A63 Castle Street Improvement, Hull

DCO Documents Errata

- 1.1.1 This Errata lists amendments to the Development Consent Order (DCO) documents which formed the A63 Castle Street Improvement, Hull application submitted to the Planning Inspectorate in September 2018. The Errata focuses upon corrections as opposed to typographical errors. Documents are presented in the order with which they were submitted for DCO.

Volume Title: VOLUME 2 FIGURE 2.5.4 THE SCHEME PROPOSALS - SHEET 3 OF 8

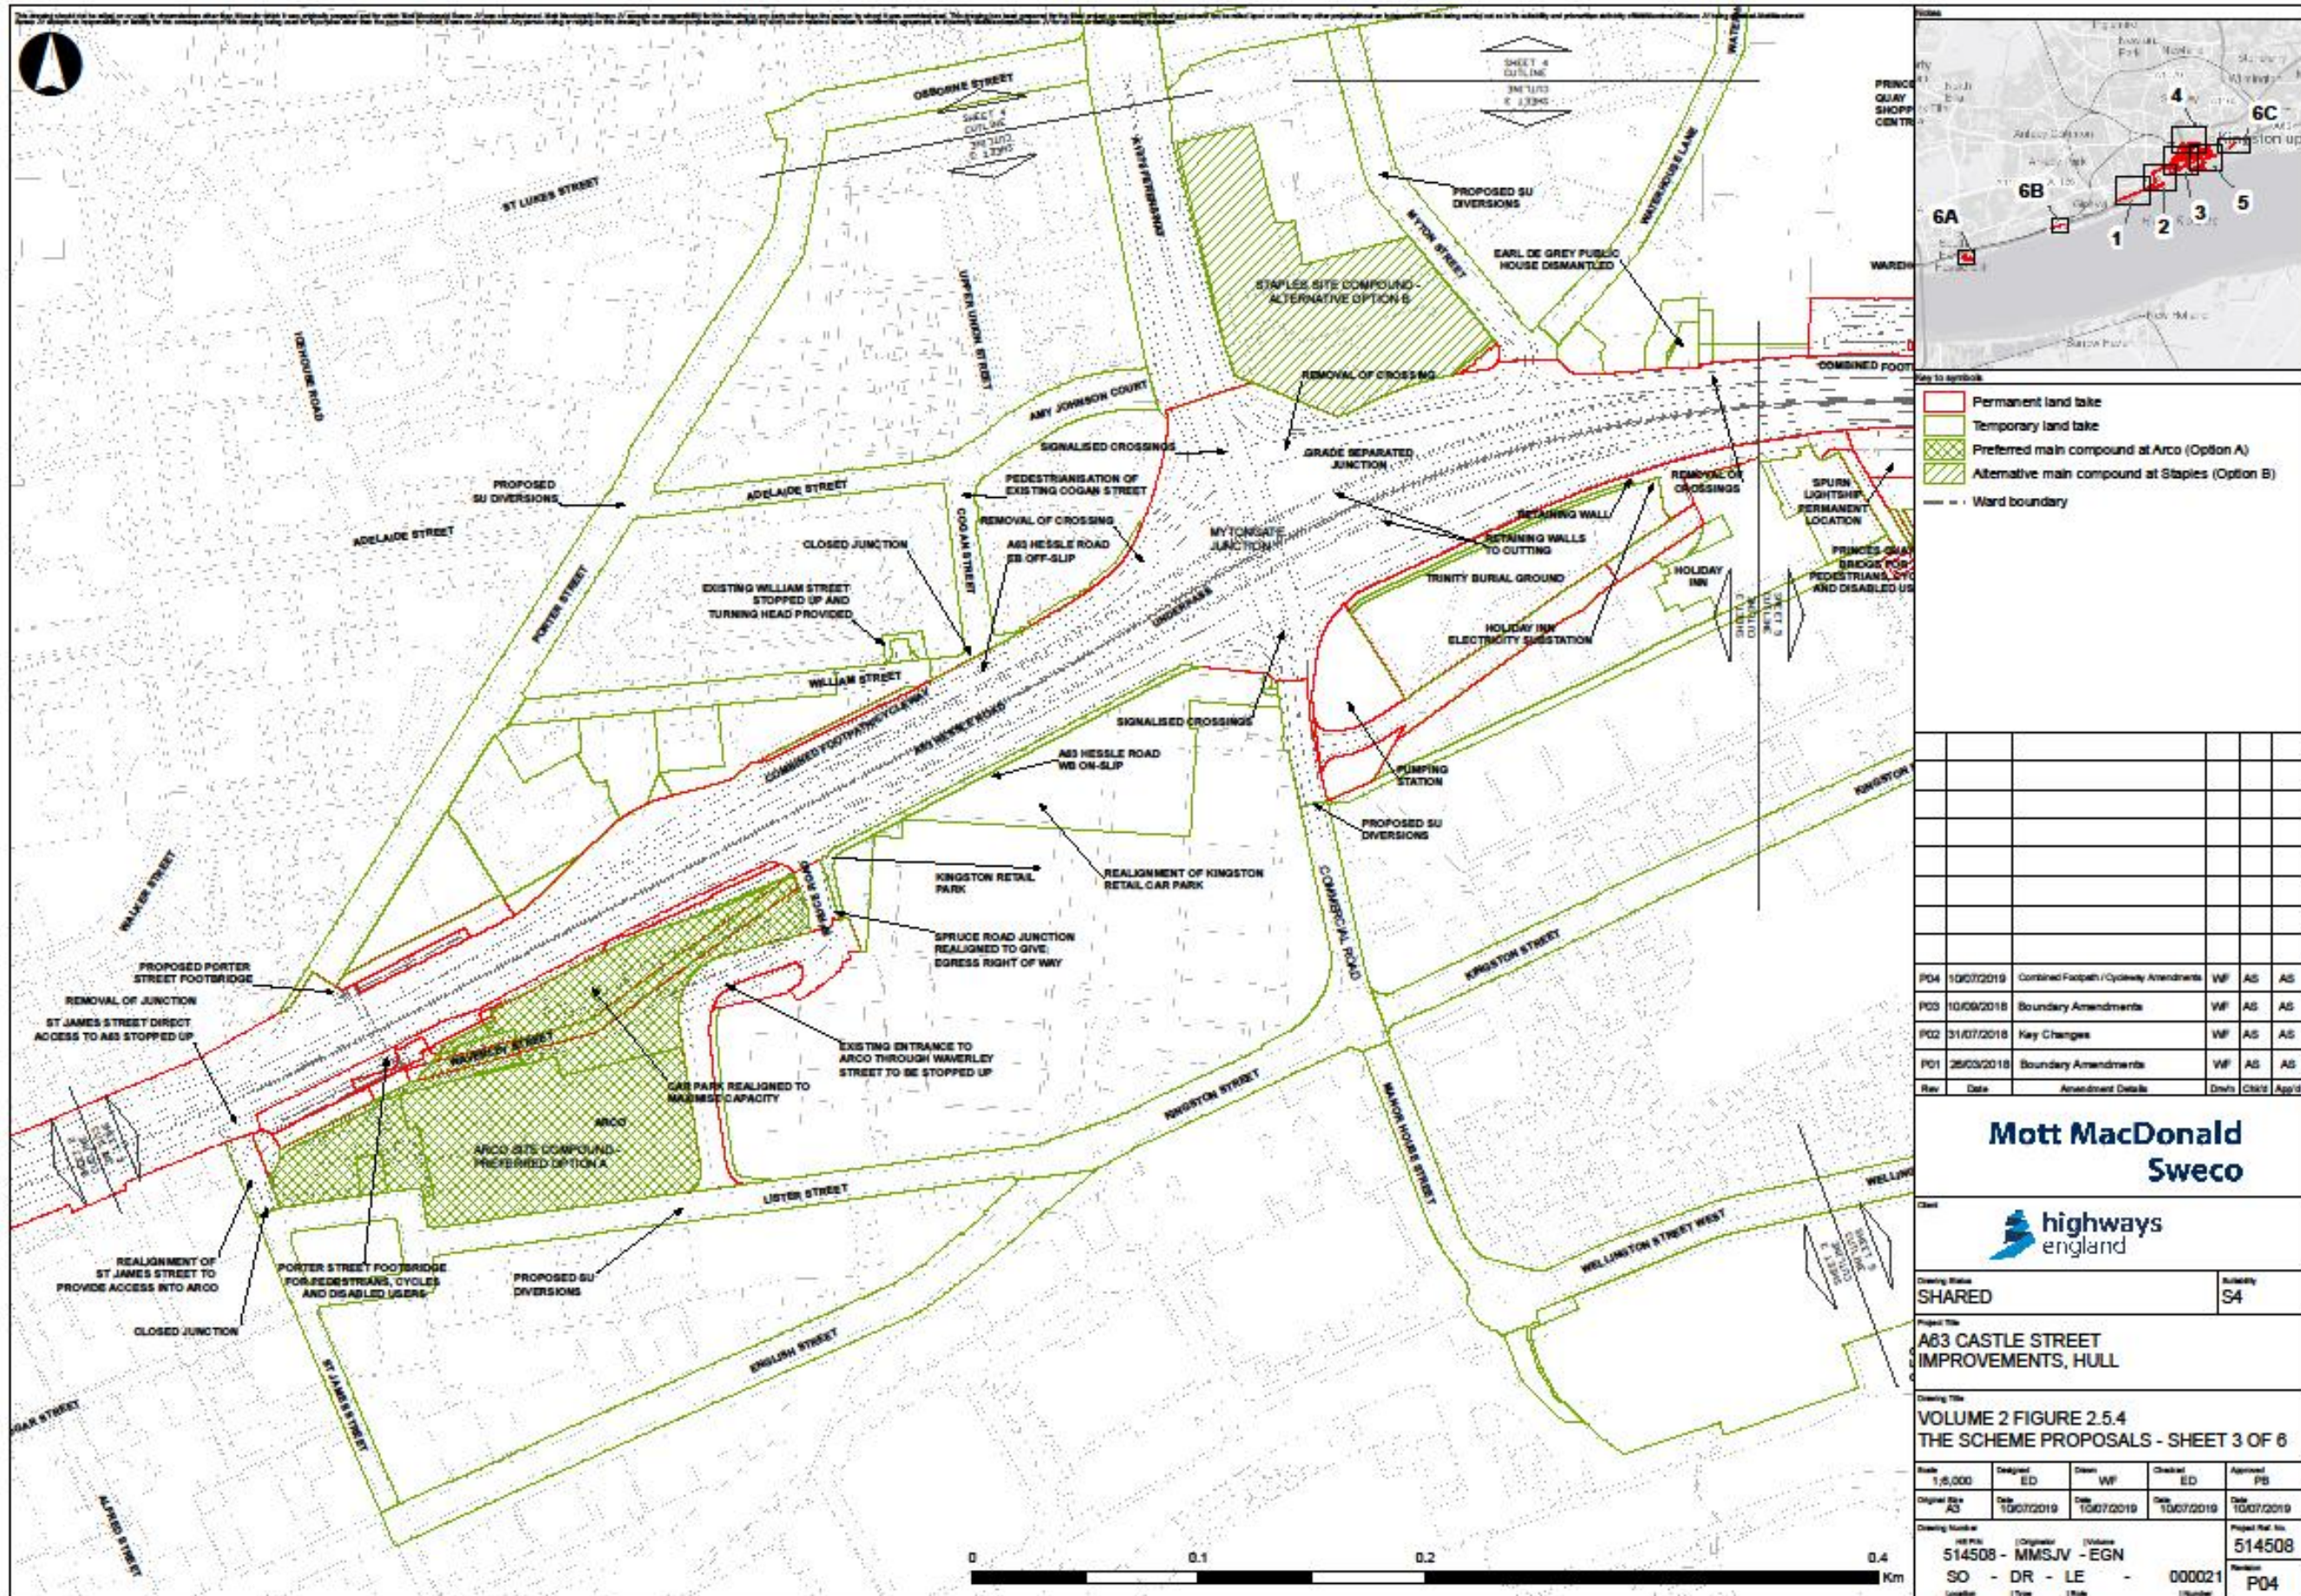
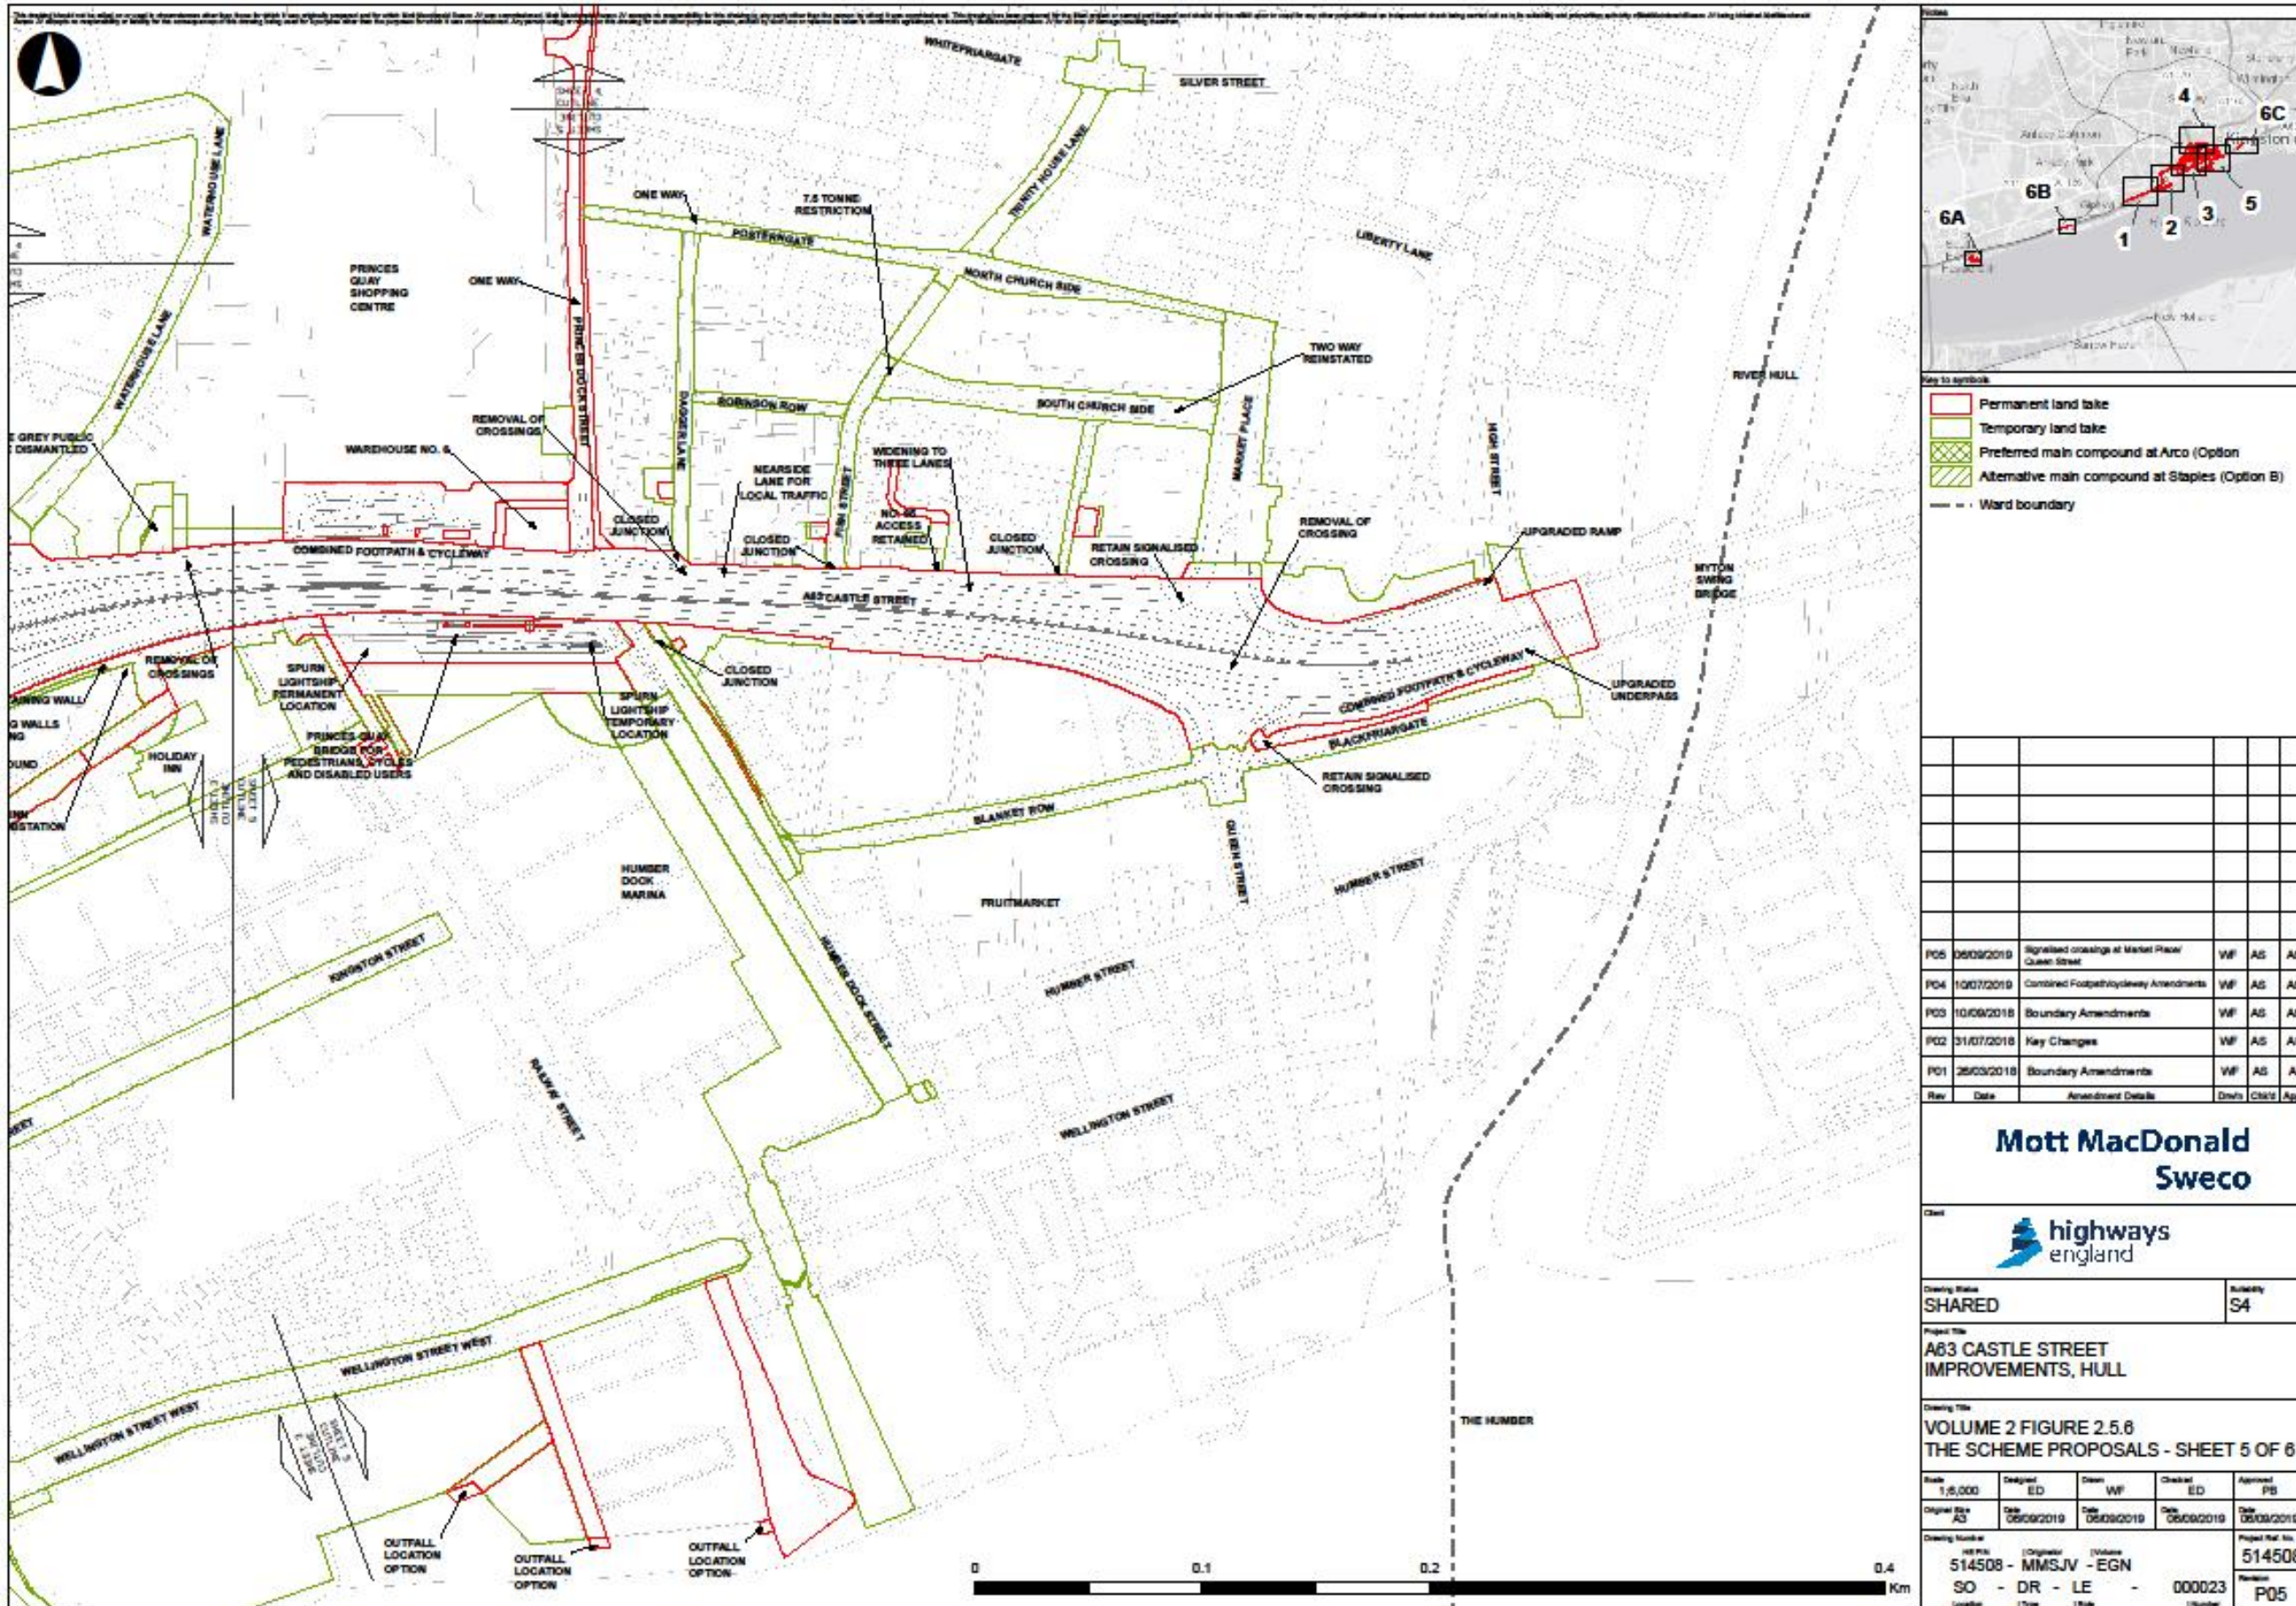
3.1.1 Replace ES Volume 2 Figure 2.5.4 The Scheme Proposals – Sheet 3 of 6 and Figure 2.5.6 The Scheme Proposals – Sheet 5 of 6 (APP-025) with the new Figures 2.5.4 and 2.5.6 below. Changes are as follows:

Drawing Title
**NON-STATUTORY DESIGNATED SITES
 VOLUME 2 FIGURE 10.2**

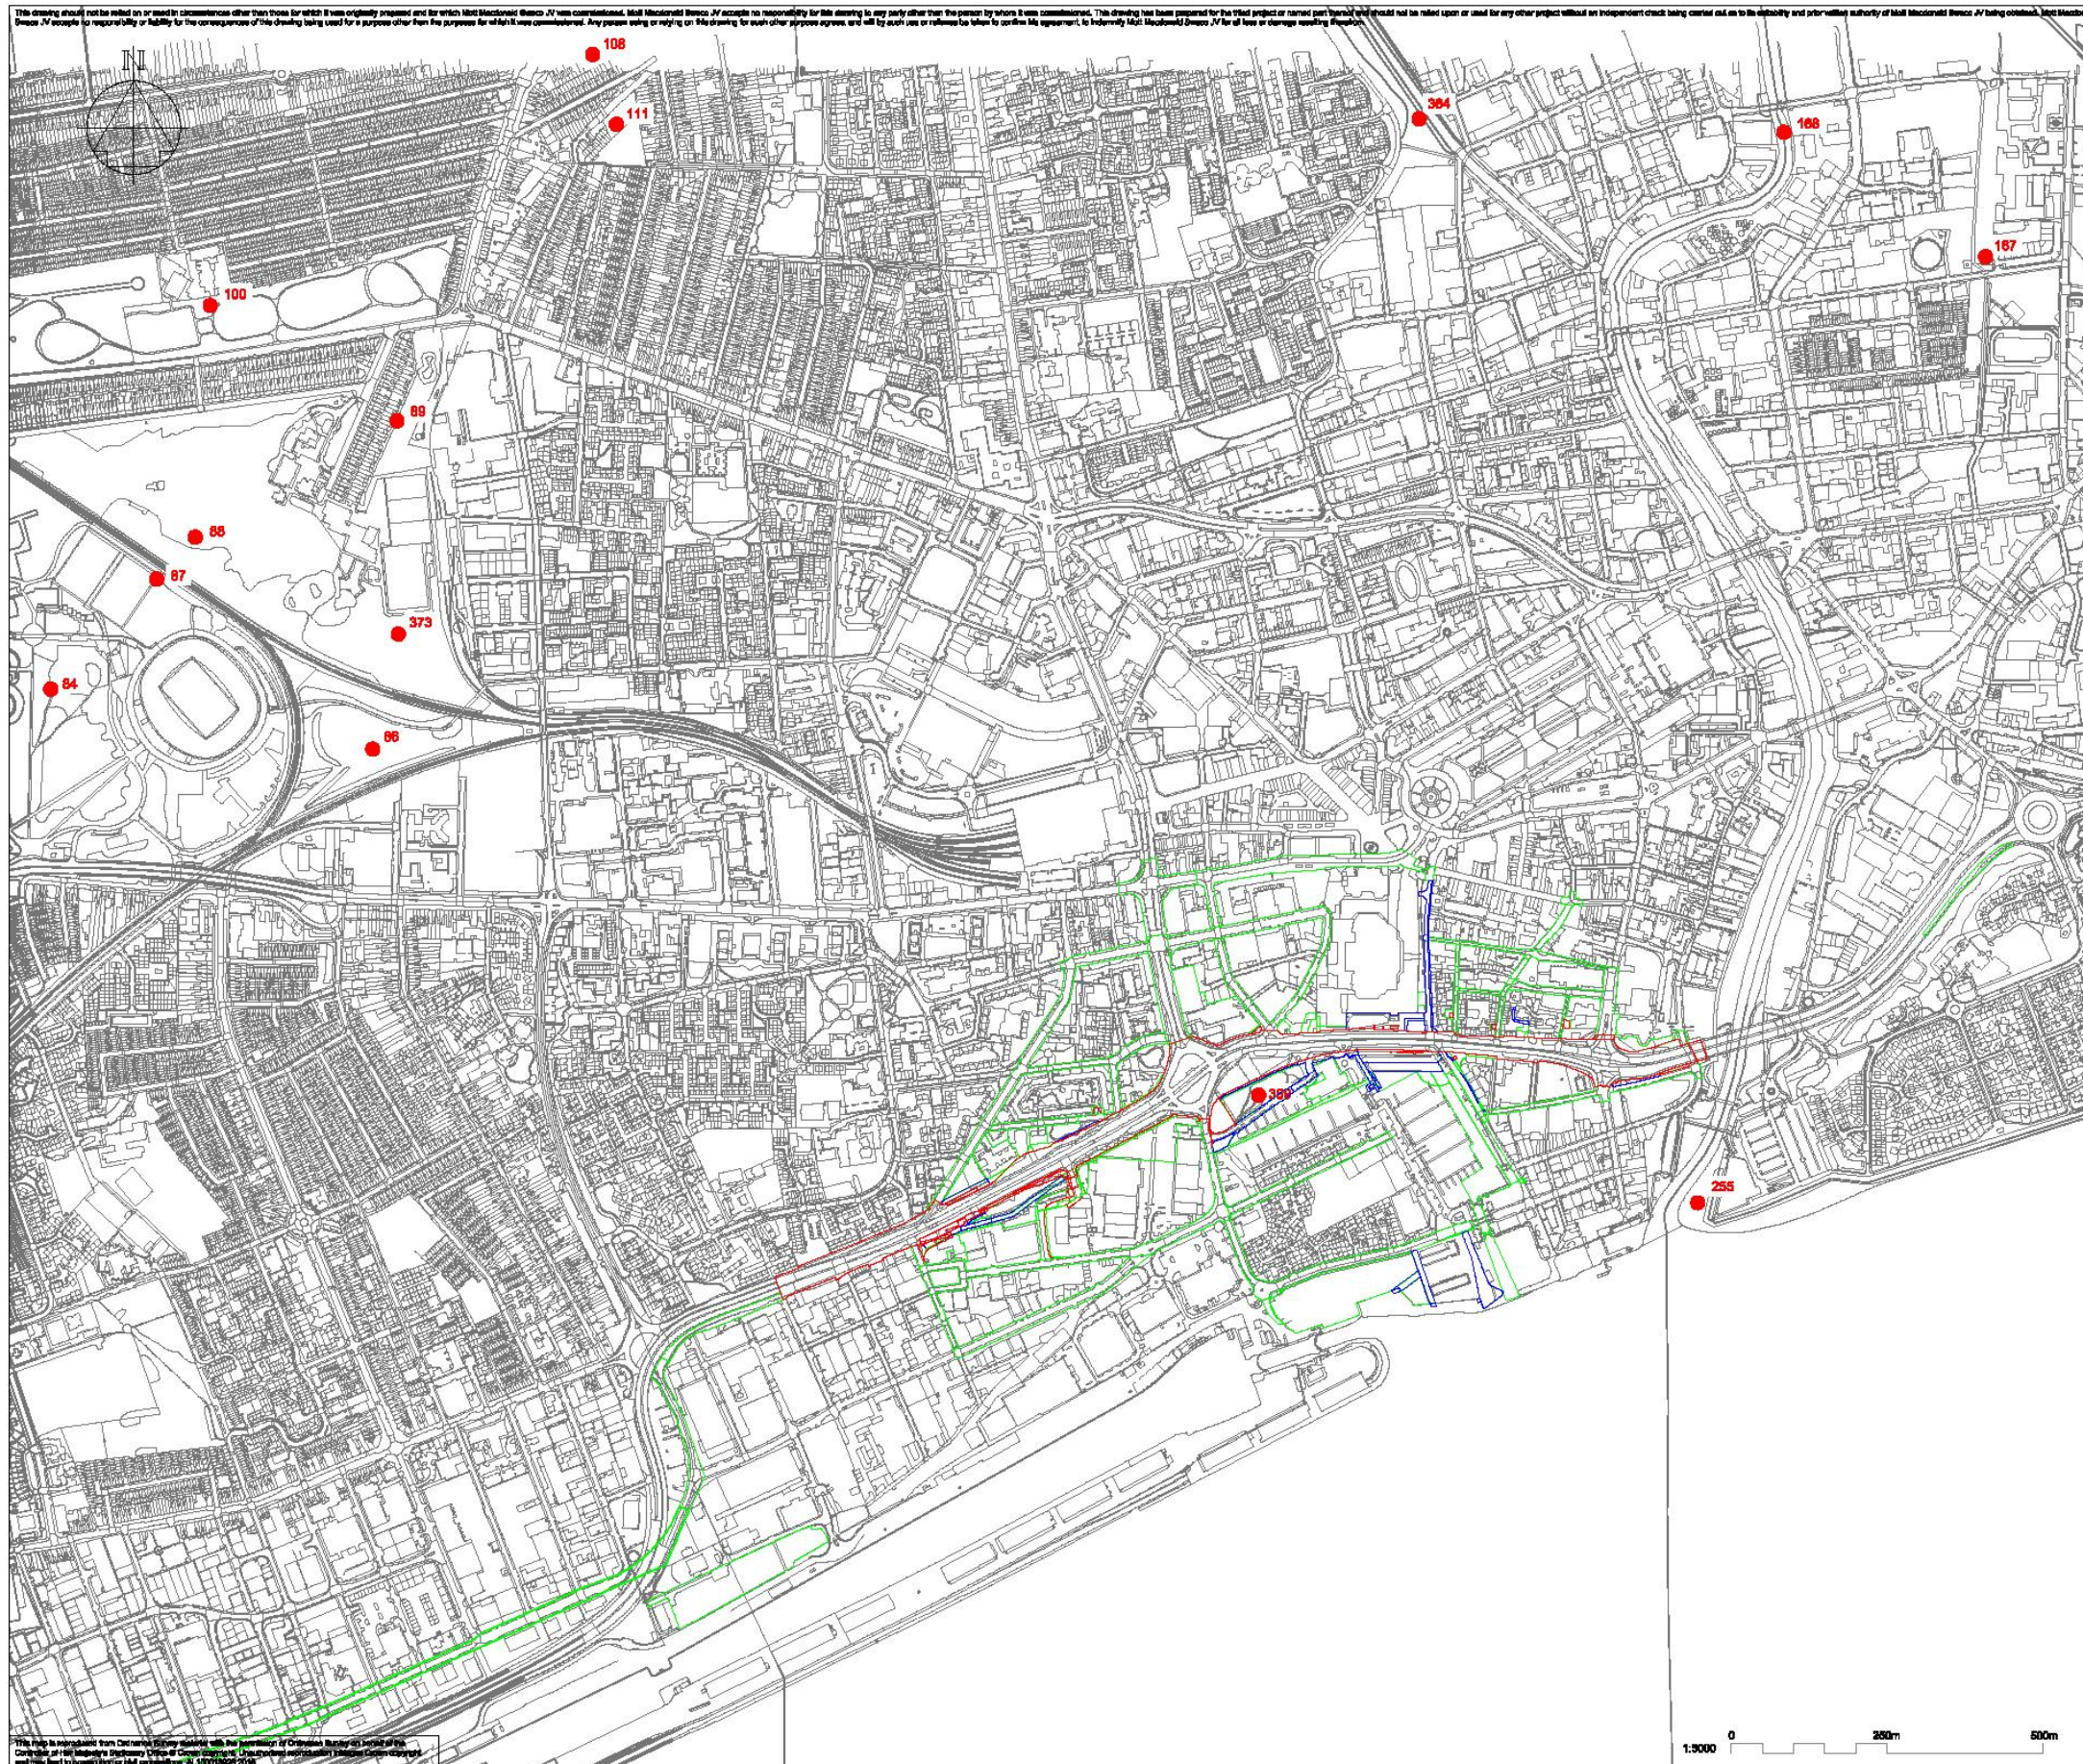
4.1.1 Replace ES Volume 2 Figure 10.2 Non-statutory designated sites (APP-036) with the new Figure 10.2 Non-statutory designated sites as below. Changes are as follows:

- The key has been replaced.
- Sammy's Point Site of Nature Conservation Interest (SNCI) has been added to Figure 10.2 as the mudflats are 250m from the Site boundary.
